MN/AN  
17042  
26 May 2017

**S.75W MODIFICATION TO HUNTLEE MAJOR PROJECT APPROVAL MP\_10\_0137  
HUNTLEE NEW TOWN, BRANXTON**

**Figure 1** – Location of sub-stages 6-13 within the Stage 1 approval  
Source: Roberts Day

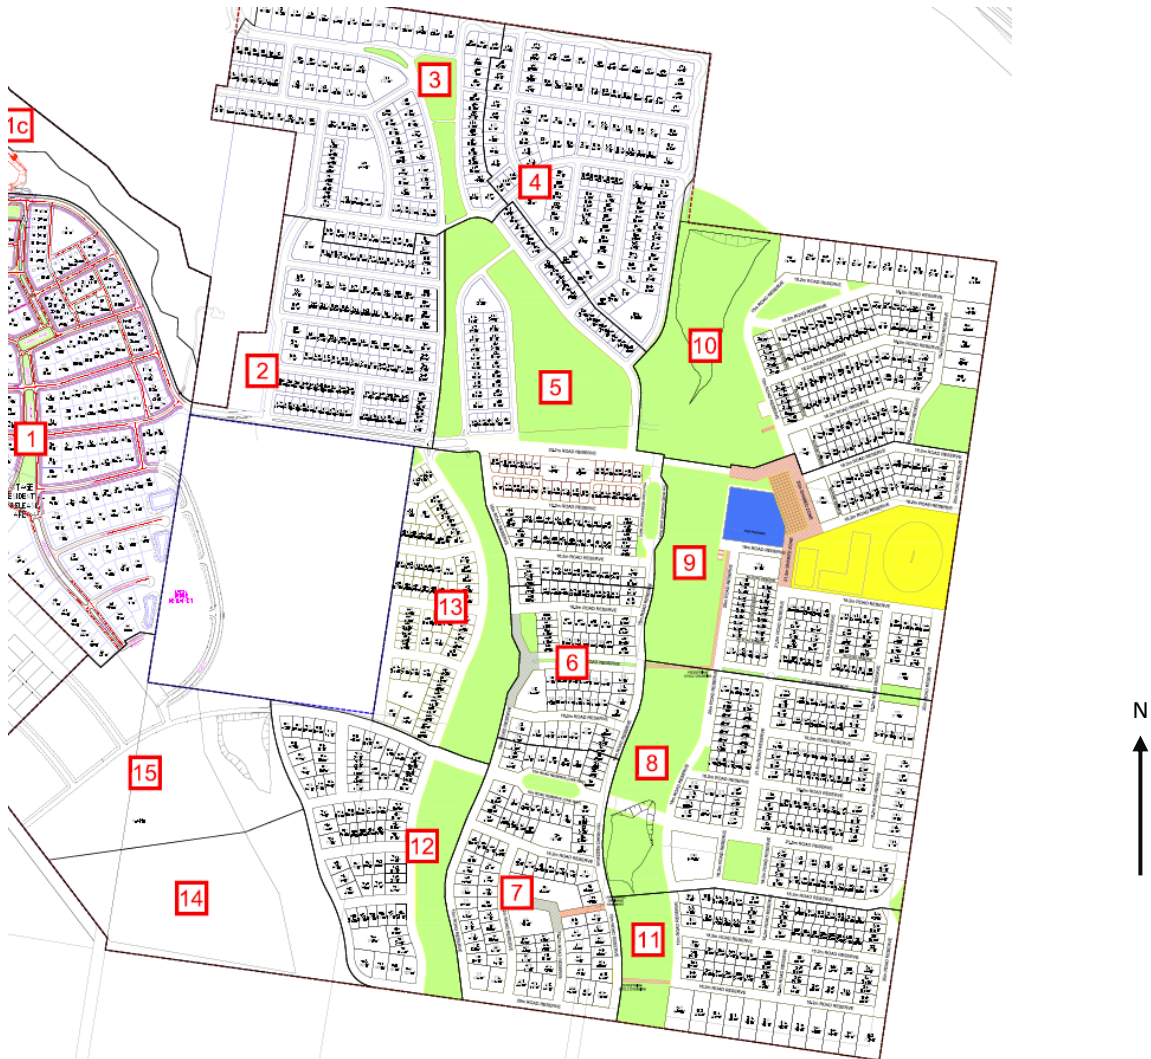
This modification seeks to reconfigure the residential lot layout within sub-stages 6-13 and subdivide the superlot in sub-stage 13 as identified in **Figure 1** below. The proposed modifications have arisen as a result of continual design improvement and respond to the reconfigured layout of in sub-stages 2-5 approved under MOD 3 (to the north of the lots affected by this modification) and relate to the residential lot layout and include associated amendments to the road network and public open space described in **Sections 2.3** and **2.4** below. The modified lot layout is shown in **Figure 1** below and a site wide Masterplan is provided at **Attachment A**. Future development on these lots will be subject to further approval.

The proposed lot layout improves the efficiency of the development by creating more linear superblocks and reducing the length of winding roads, to improve the overall legibility and permeability of the layout. The revised layout will replace curved superblocks with a more desirable grid-pattern in sub-stages 8-11<sup>1</sup>, and to the north of sub-stage 6 where lots interface with the approved linear layout of sub-stage 5 (MOD 3). Owing to the curved nature of the north/south open space corridors, contiguous curved street blocks will continue to be provided in sub-stages 6-7 and 12.

The amendments to residential allotments in the Stage 1 Project Approval site also comprises subdividing the superlot in sub-stage 13 to deliver an additional 66 lots. This will contribute to the delivery of housing in Huntlee, commensurate with the intent of this superlot.

**Figure 2 – Stage 1 Traffic Infrastructure Upgrade**

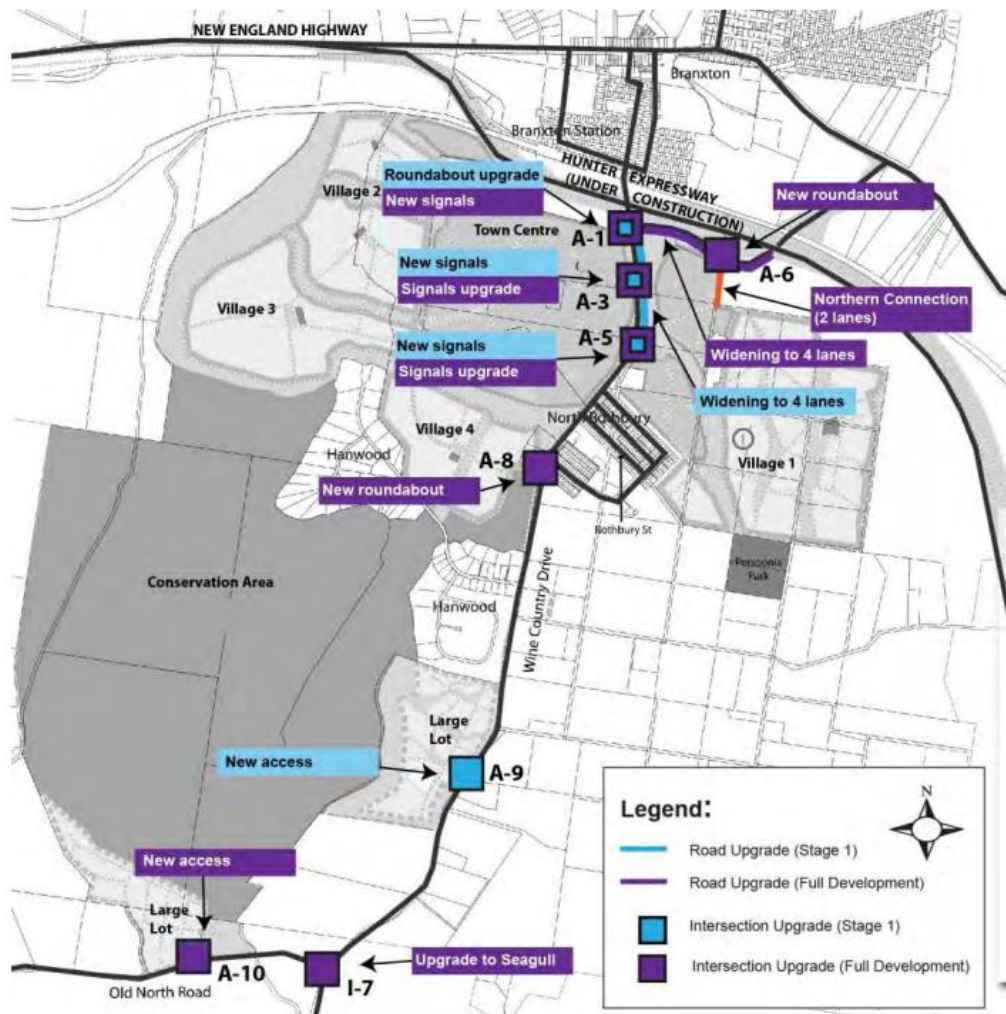
A Traffic Threshold Intersection analysis of the Huntlee Town Centre has been prepared by Better Transport Futures to analyse the threshold nominated in the MOD 6 conditions for upgrading the intersection known as 'A-1', at the junction of Wine Country Drive, Bridge Street, and the Hunter Expressway Link Road. The intersection is illustrated in **Figure 2** below. The Threshold analysis provides an assessment on the need for a fourth leg of the roundabout at this intersection to provide access to the Town Centre and reviews the threshold of 750 lots required under condition E7(a)(iii) for the upgrade of this intersection to be increased to 900 lots. The analysis builds on previous work with the RMS completed under MOD 6. This analysis accompanies the modification application at **Attachment E**, and is discussed further in **Section 3.4**.

- (iii) The Wine Country Drive / HEx Link Road (A–1) intersection shall be upgraded, to a 2 lane circulating roundabout prior to ~~725~~ 900 dwellings for which a subdivision certificate has been issued, or 1 June 2018, whichever occurs first.

**Figure 4** – Proposed Asset Protection Zones (shown in red)

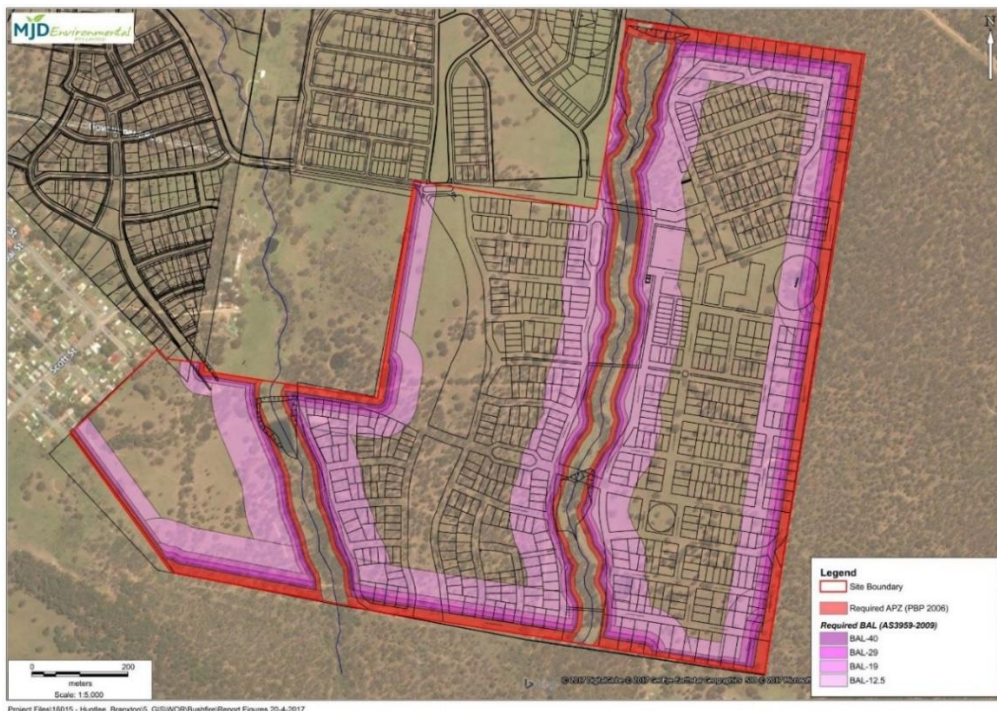
A Bushfire Threat Assessment Report (BTA) has been prepared by MJD Environmental and is provided at **Attachment D**. The BTA provides an assessment of the potential bushfire impacts on the modified sub stages 6-13, and has considered the bushfire setting for sub stages 14 and 15 for completeness. The BTA provides a slope assessment for a distance of 100m around the Site and an assessment of the surrounding vegetation and future land uses. The BTA confirms that the site is located on bushfire prone land and contains Category 1 and 2 Vegetation as well as Vegetation Buffer lands. The Assessment recommends the implementation of Asset Protection Zones (APZs) (**Figure 3**), which will be accommodated in the road carriageways or large lots. These APZs are detailed below in addition to other fire mitigation and control measures:

- Roads are to be constructed in accordance with PBP 2006 as outlined within the BTA;
- Consideration should be given to landscaping and fuel loads on site to decrease potential fire hazards on site; and

- Any proposed development is to be linked to the existing mains pressure water supply and that suitable hydrants be clearly marked and provided for the purposes of bushfire protection. Fire hydrant spacing, sizing and pressure should comply with AS2419.1, 2005.
